DATE: February 7, 2011

SUBJECT: Addendum No. 3
Green Valley Road at Tennessee Creek Bridge Replacement Project
(Contract No. PW 09-30407, CIP No. 77109)

GREEN VALLEY ROAD AT TENNESSEE CREEK
BRIDGE REPLACEMENT PROJECT
6" WATERLINE - PLAN & PROFILE

SHEET
W-2
53 OF 61
W.O. No. 77109

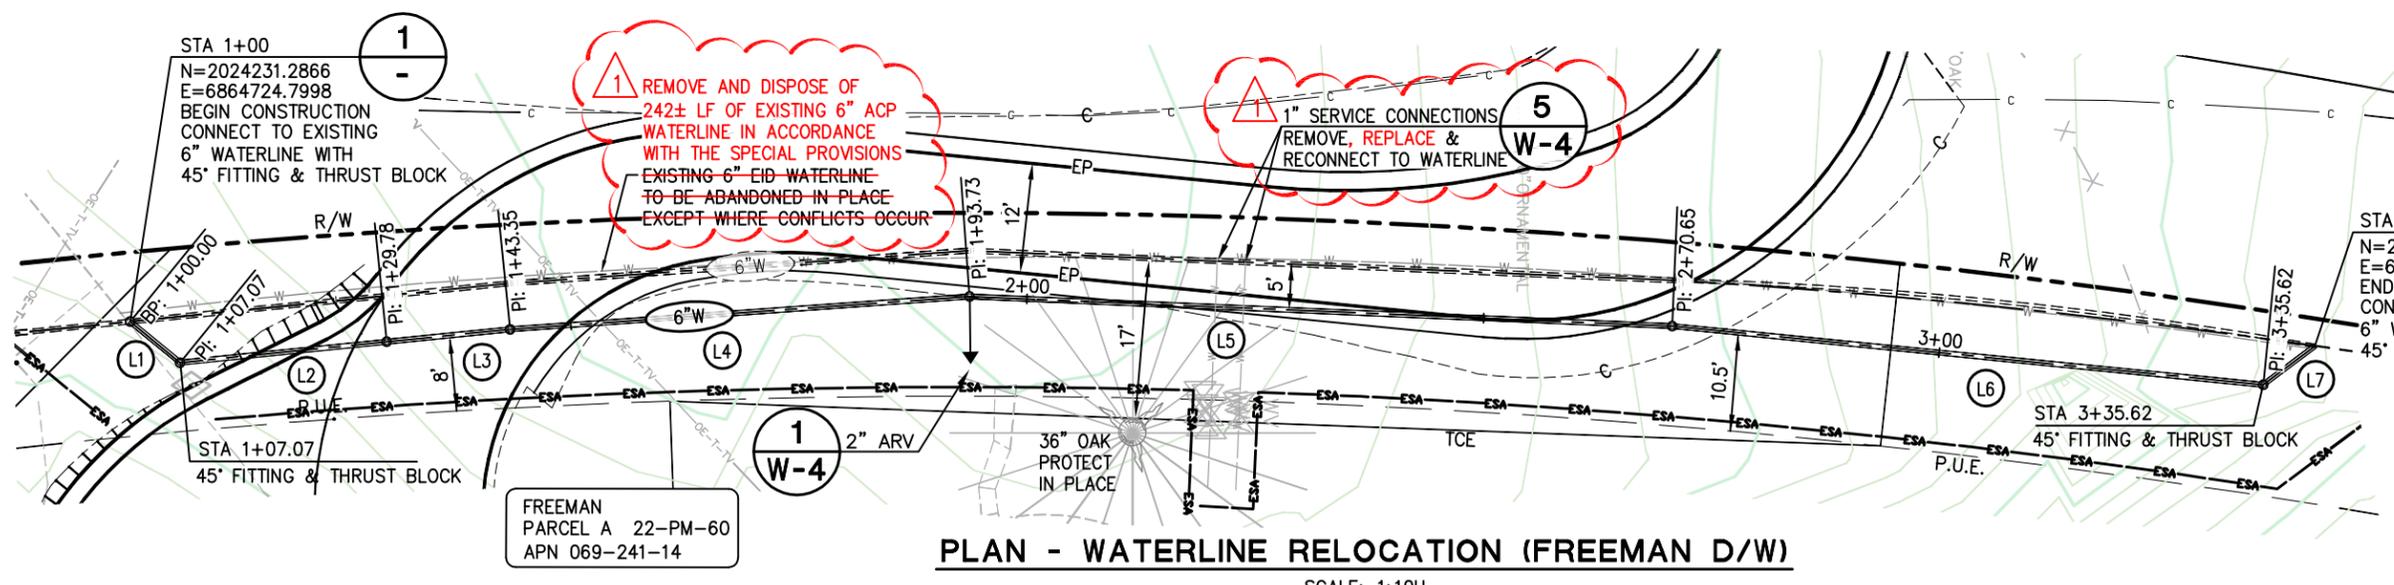
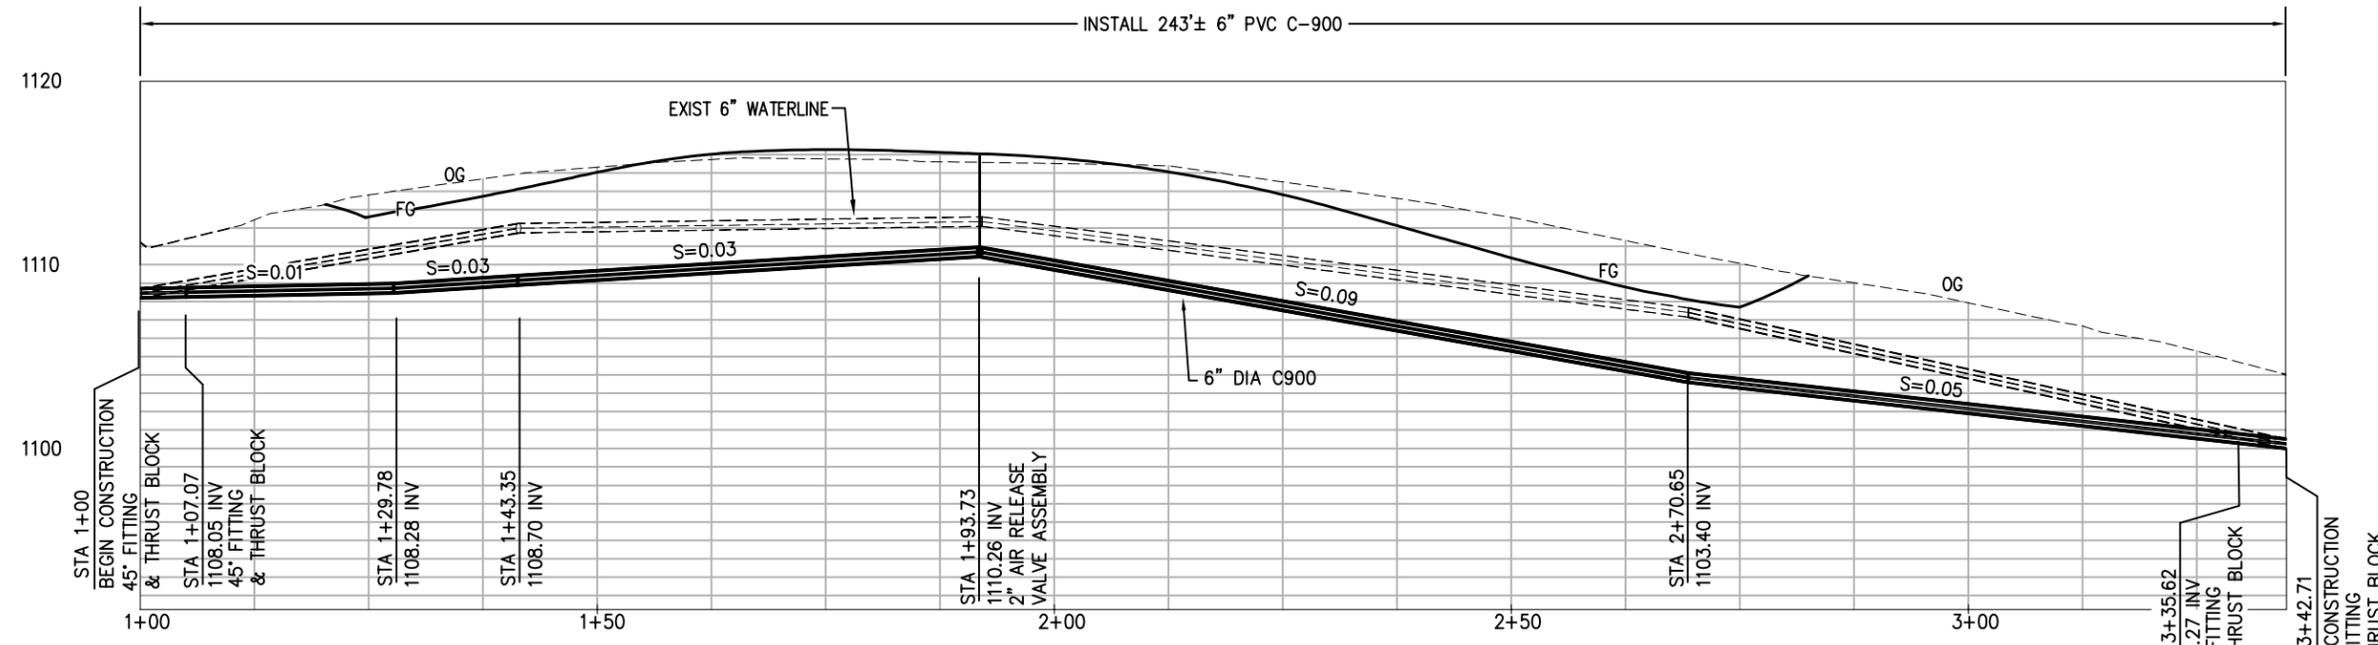
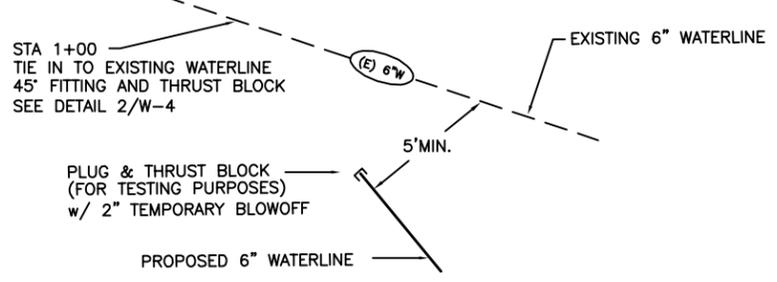
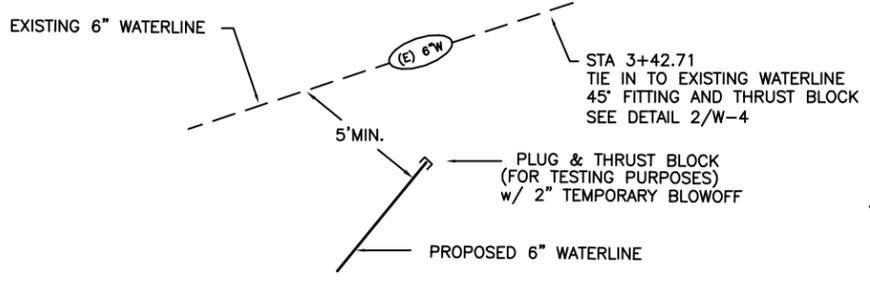
ITEM NO.	LOCATION, PAGE OR DRAWING NO.	DESCRIPTION OF CHANGE
3.01	Plan Sheets 53 and 54	To address the bidder's question regarding the quantity of "asbestos containing material removal" and 1" service lines plans sheets W-2 (53 of 61) and W-3 (54 of 61) have been revised. Bidders are instructed to replace original plan sheets 53 of 61 and 54 of 61 with the revised sheets 53 of 61 and 54 of 61 attached to this Addendum No. 3.
